Service Bulletin

Bulletin No. 2010-04 OEM No. 2010-03

Gen II Propeller Sets for Bravo Three Sterndrives

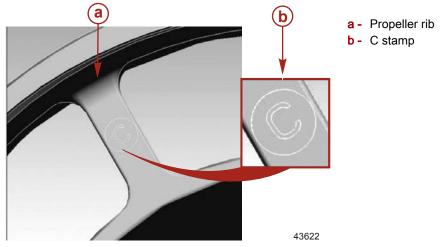
The front, 4-blade propeller for Gen II propeller sets on Bravo Three sterndrives has been redesigned to improve acceleration, enhance performance and reduce slip in many applications. The new design affects the 20-pitch, 21-pitch, and 22.5-pitch 4-blade front propeller only.

The new 4-blade front propellers carry the same part numbers as the original 4-blade front propellers and can be identified by a C stamped on the rib of the propeller hub as shown:

IMPORTANT: These 4-blade propellers cannot be mixed on dual engines with the old-style 3/3 front propellers. Always run the matching sets on dual-engines (3/3 or 4/3 propeller sets).
